STAFF RECOMMENDATION

418 Fairfax Avenue
January 16, 2019

Application: New Construction; Outbuilding; Setback Determination
District: Hillsboro-West End Neighborhood Conservation Zoning Overlay
Council District: 18
Map and Parcel Number: 10410014400
Applicant: Tyler LeMarinel, Allard-Ward Architects
Project Lead: Jenny Warren, jenny.warren@nashville.gov

<p>Description of Project: The applicant proposes to construct an addition to an existing outbuilding. The work requires a side setback determination, and the design includes a wall dormer.</p> <p>Recommendation Summary: Staff recommends approval of the proposed outbuilding with the condition that the roofing color, windows, pedestrian and garage doors shall be approved administratively prior to purchase and installation. With this condition, Staff finds that the proposal would meet the design guidelines for additions in the Hillsboro-West End Neighborhood Conservation Zoning Overlay.</p>	<p>Attachments A: Photographs B: Site Plan C: Floor Plans D: Elevations</p>
---	--

Figure 6: Site plan – note garage location, 10'2" from property line. The addition to the main house was approved by the Commission in December 2018, and has not yet been constructed.

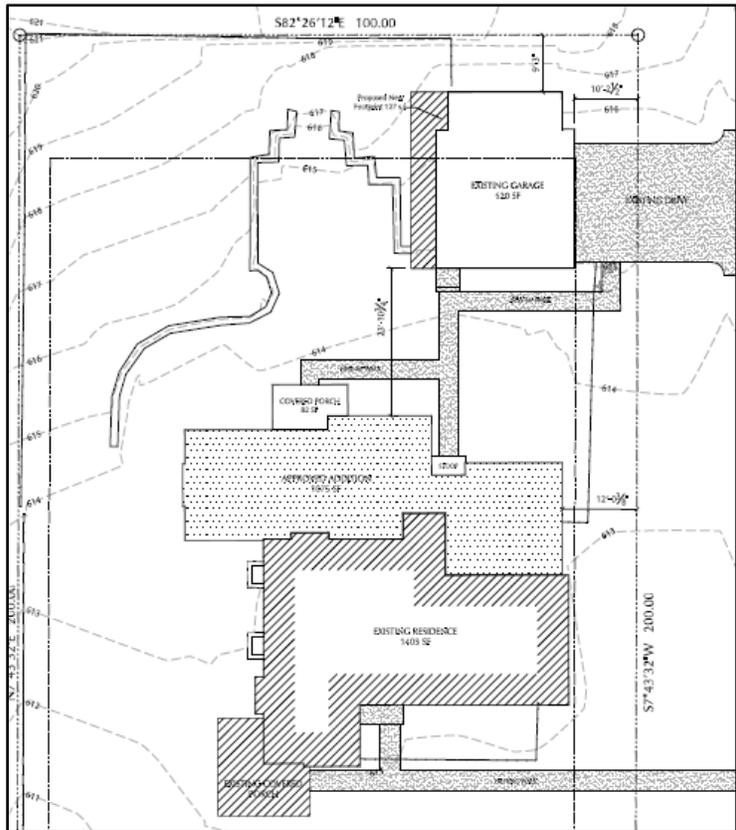
The existing garage sits about ten feet, two inches (10'2") from the side property line, along 32nd Avenue, South. Base zoning requires at least a twenty foot side setback for garages with doors facing a side street. Staff finds that maintaining the existing side setback is appropriate in this instance as the outbuilding is set back approximately flush with the side setback of the main house. Further, although the garage is only setback ten feet 2 inches (10'2") from the property line, it is

setback nearly twenty-six feet (26') from the street.

The existing garage sits about forty feet (40') from the rear of the existing house. The previously approved addition will bring the house closer, to about twenty-three feet, ten inches (23'10") from the garage. The proposed outbuilding work will not impact this separation, as the south wall of the outbuilding is remaining in place. Staff finds this separation to be appropriate as it is more than the required twenty feet (20').

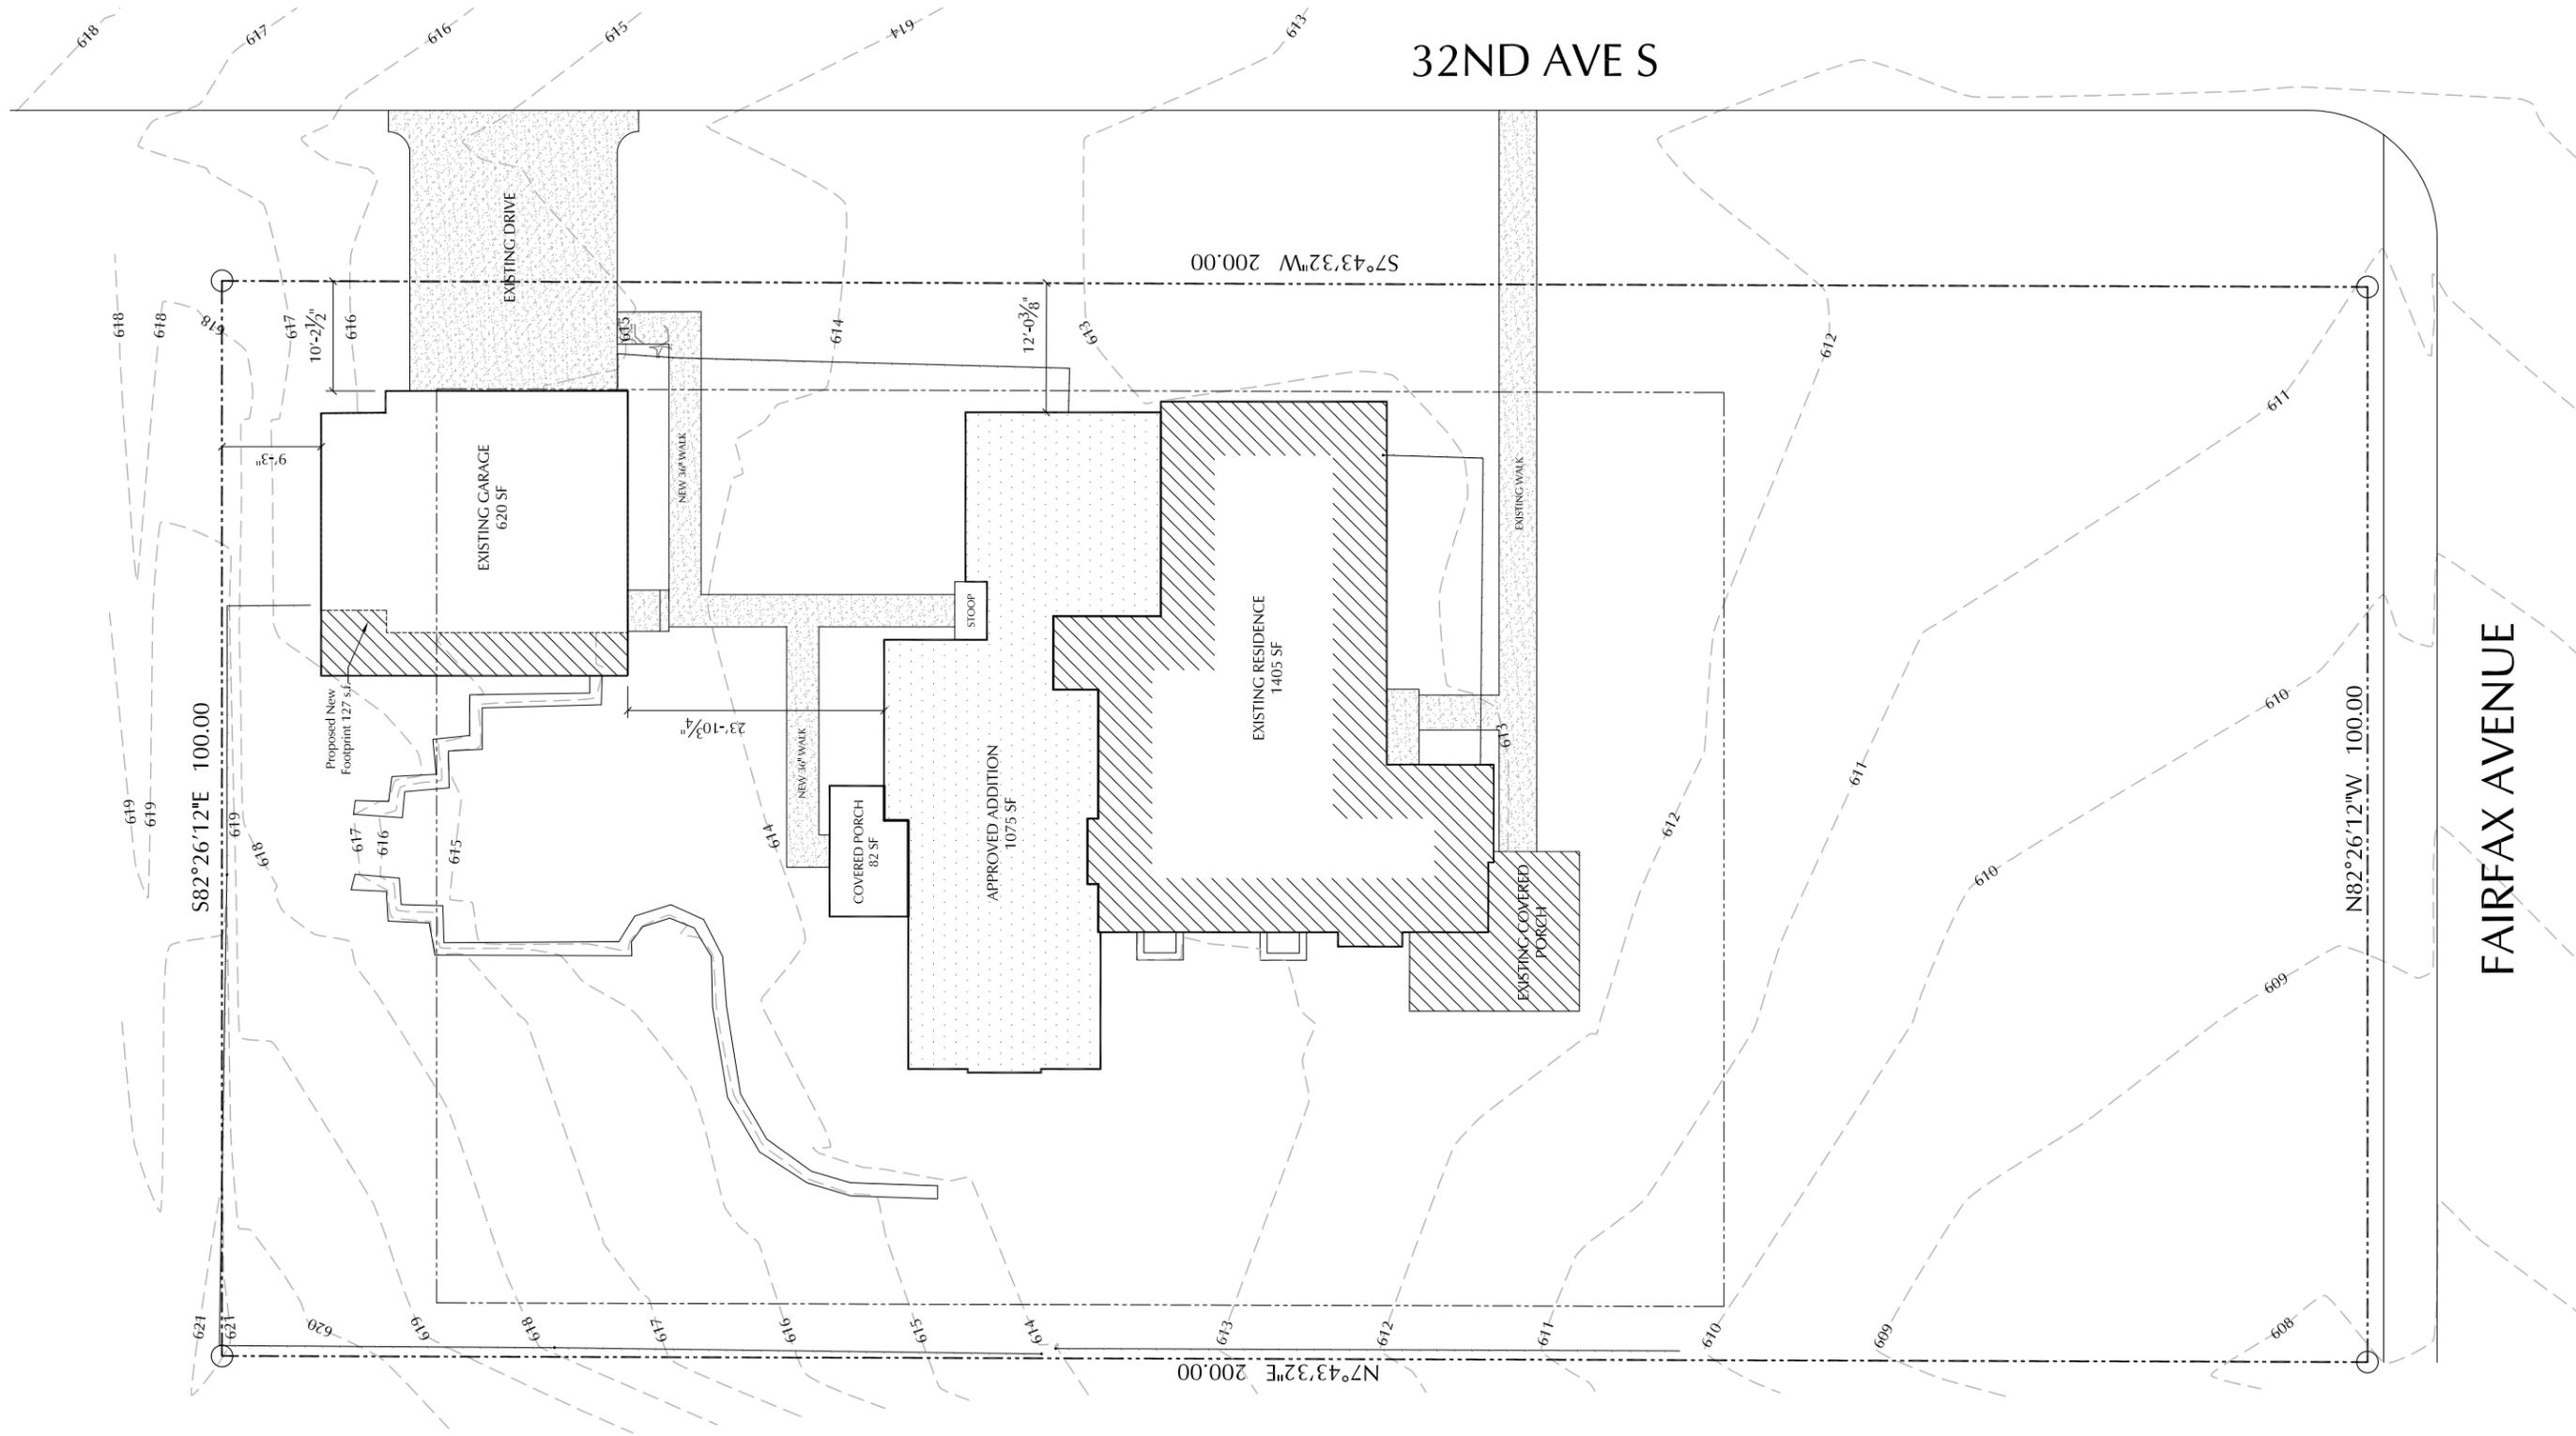
With staff-level approval of the roofing color, windows, pedestrian door and garage doors, prior to purchase and installation, staff finds the materials to be appropriate.

Recommendation: Staff recommends approval of the proposed outbuilding with the condition that the roofing color, windows, pedestrian and garage doors shall be approved administratively prior to purchase and installation. With this condition, Staff finds that the proposal meets the design guidelines for additions in the Hillsboro-West End Neighborhood Conservation Zoning Overlay.

1 West Elevation

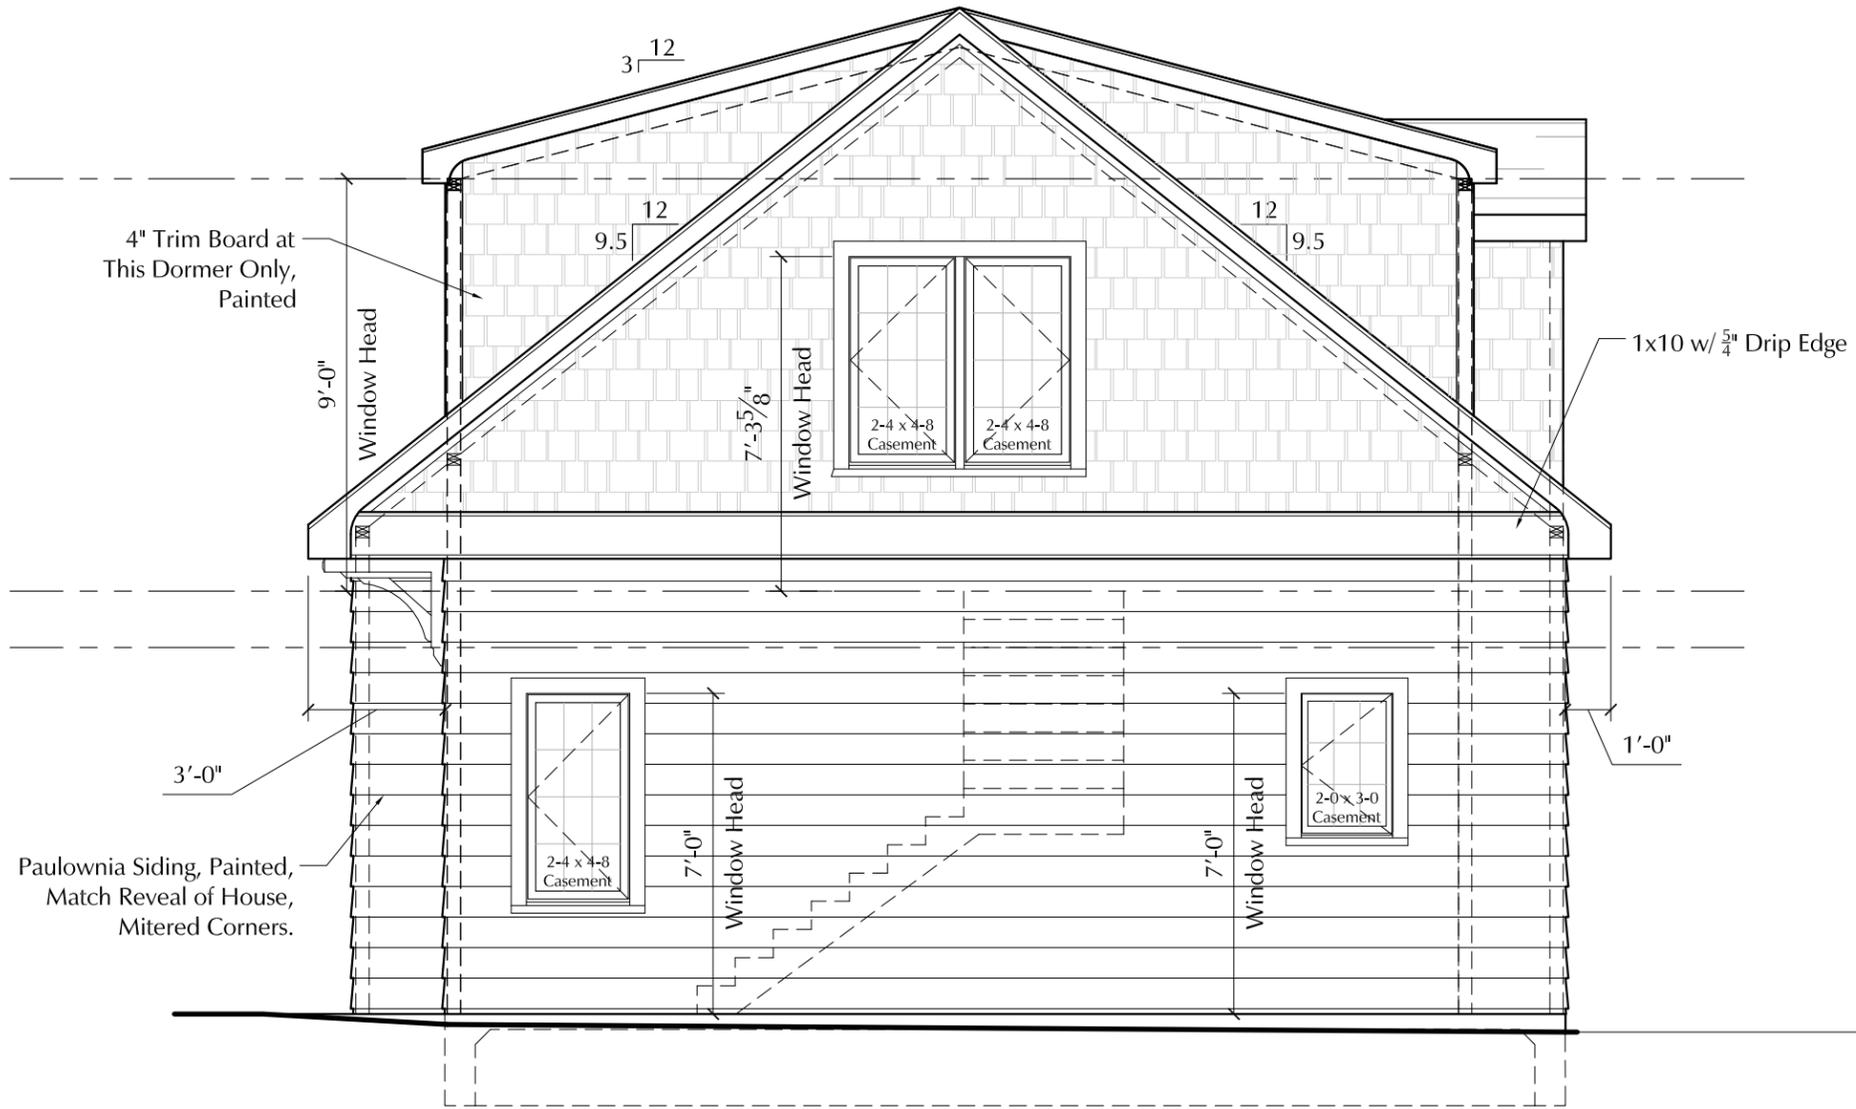
The design proposes to incorporate a wall dormer on the west elevation. A ‘wall dormer’ is a dormer where the face is flush with the wall below. The guidelines state that dormers *should sit back from the exterior wall by 2’*, therefore this is a standard recommendation by staff; however, in this particular instance, the historic house does have a wall dormer on the front façade (Figure 3).

Because the main house features a similar dormer and because the proposed location faces the interior of the lot, away from the street, staff finds that the proposed wall dormer could be appropriate in this particular instance.

Figure 5: West elevation. Note the proposed wall dormer
